ADDRESSEES	: Owners and operators of vehicles listed under “Application” ABC Customer Care and Parts Source
VEHICLE MODEL	: CX35, CX45, TX45, TD925US, TDX25US, AG300
MANUAL CHAPTER	: 02.10 Engine – Fuel system
BULLETIN TYPE	: Safety Recall NHTSA 21V-385
DATE	: July 06 th , 2021
SUBJECT	: High pressure fuel rail assembly may leak fuel
CONDITIONS	: -

***** IMPORTANT SAFETY RECALL *****
NHTSA Recall No. 21E-032
Cummins Campaign #C2423

Technical Service Bulletin: TSB210113	Released Date: 30-Jul-2021
Fuel Rail Assembly Inspection and Repair Procedure: External Fuel Leaks

Figure 1, Removing the pressure relief valve and the high pressure fuel fitting.

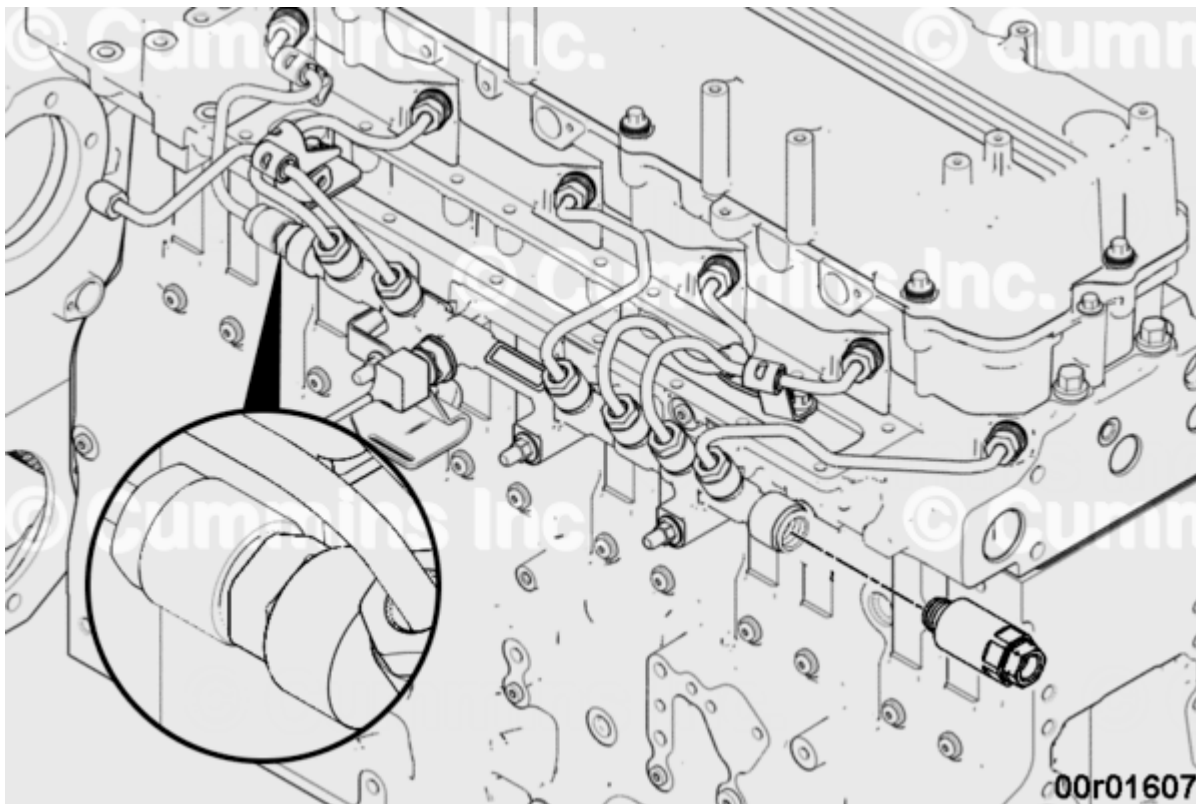
- Remove the pressure relief valve and the high-pressure fuel fitting from the fuel rail.

Figure 2, Removing Sealing Washer from Fuel Rail.

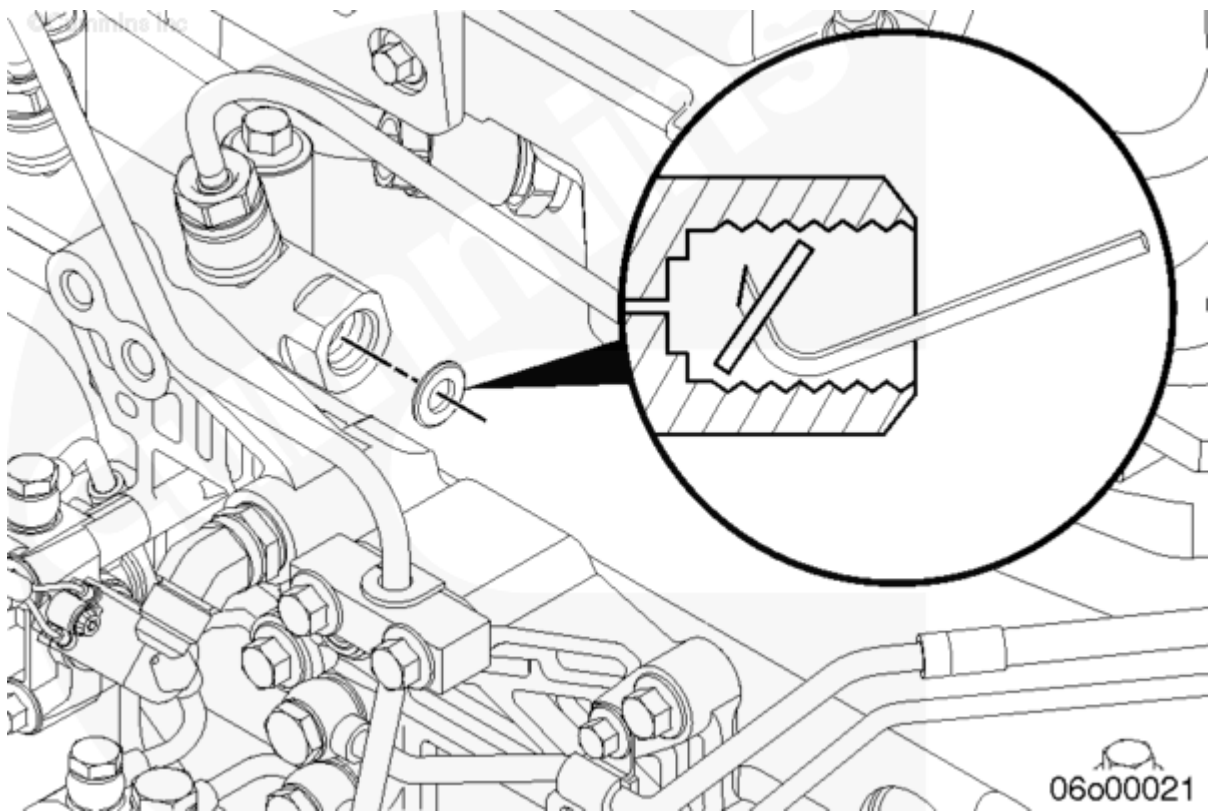
- Remove and discard the sealing washers. The procedure below outlines how to remove the sealing washers.

Special care should be taken to avoid damage to threads during removal process.

- A special tool **must** be created for the removal of the sealing washers by grinding a 45 degree angle on the short leg of a 1/8-inch or 3/16-inch Allen wrench, so that the wrench is no longer than 13 mm [½ in] long (measured from the outside of the long leg.)
- This tool acts as a mini heel bar to pry out the sealing washer without damaging the back of the hole.
- Use the modified Allen wrench to pry out the old sealing washer from the threaded hole in the fuel rail. Considerable force is required to remove the sealing washer.

Figure 3, Threads That Do Not Meet Reuse Guidelines.

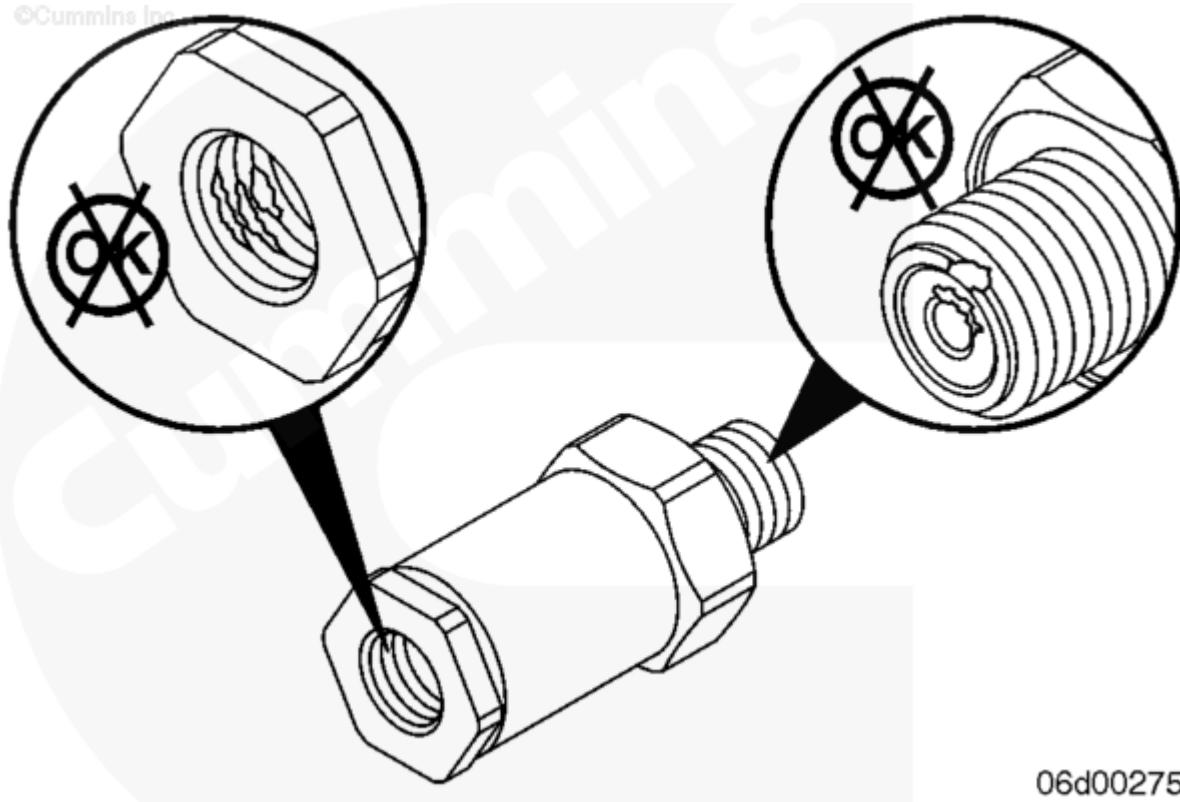
- Visually inspect the thread surfaces of the fuel rail, fuel pressure relief valve and the high-pressure fuel fitting for damage. Review Figures 3 and 4 below for guidance.
- Do **not** reuse components if the threads or sealing surfaces are damaged.

- If the threads or sealing surfaces are damaged, replace the fuel rail assembly. See corresponding Service Manual. Reference Procedure 006-060, 006-061 in Section 6 and Technical Service Bulletin, New Fuel Rail, High Pressure Injector Supply Lines, Fuel Supply Line, and Fuel Supply Line Braces, TSB210055 for directions.
- If the threads or sealing surfaces are **not** damaged, install the pressure relief valve and the end fitting with the following procedure:

Figure 7, Installing Sealing Washer with The Seal Installer Tool.

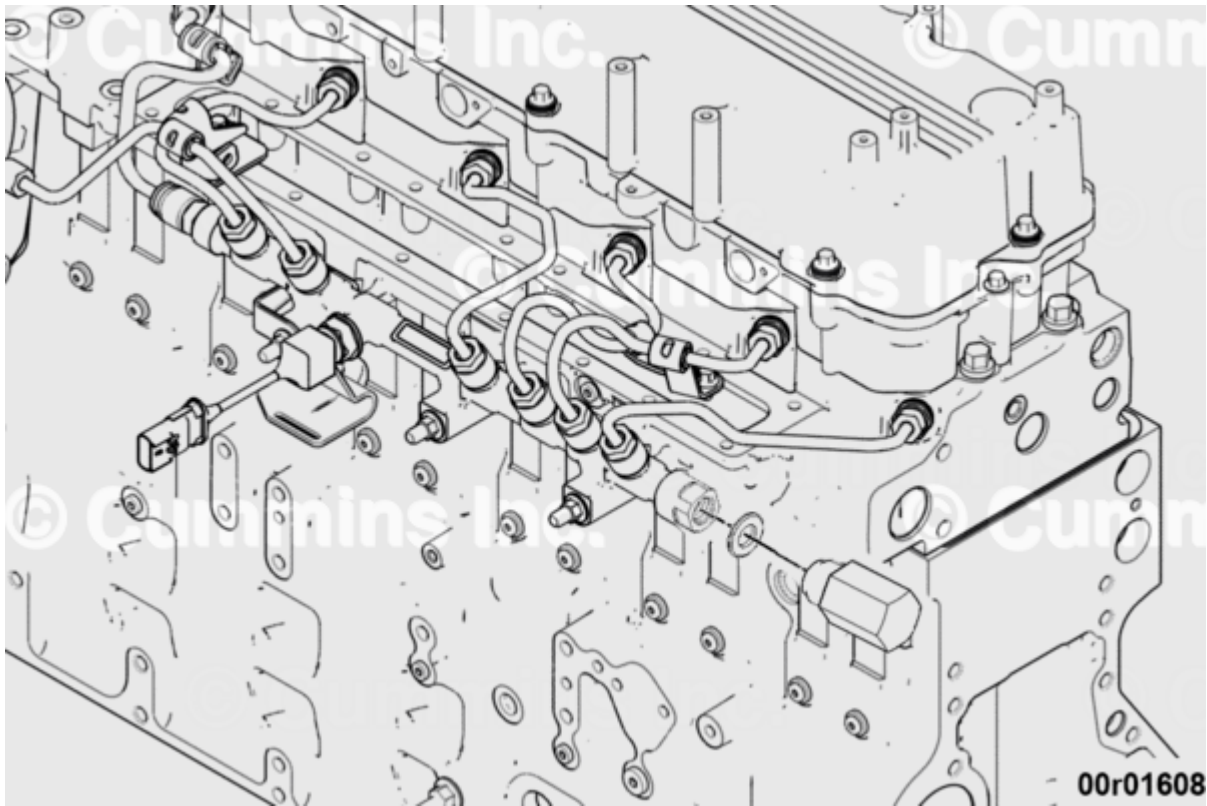
2. Install a new sealing washer on the pressure relief valve bore in the fuel rail. Use assembly lubricant, Part Number 3163087, or equivalent, on the threads and the face of the seal installer tool. Use seal installer tool, Part Number 5573487, to seat the sealing washer fully in the fuel rail bore.

3. Torque the seal installer tool.

Torque Value: 81 n•m [60 ft-lb]

Figure 8, Left: Sealing Washer Not Installed, Right: Sealing Washer Installed Correctly.

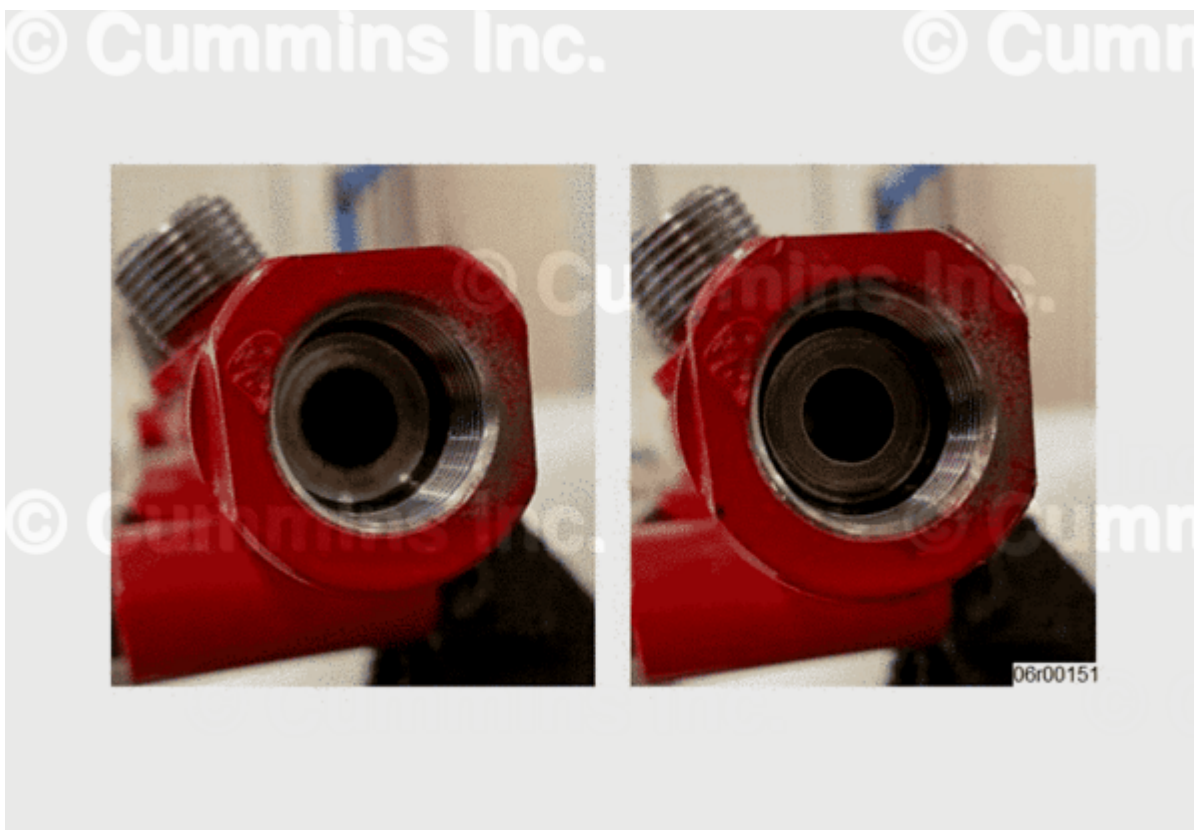
4. Remove the seal installer tool after the sealing washer has been installed. Verify that the sealing washer remains seated inside the fuel rail after the seal installer tool is removed.

9. If either of the sealing washers do **not** remain seated inside the fuel rail after the seal installer tool has been removed, use of seal installer tool is not required. Install washer in bore.
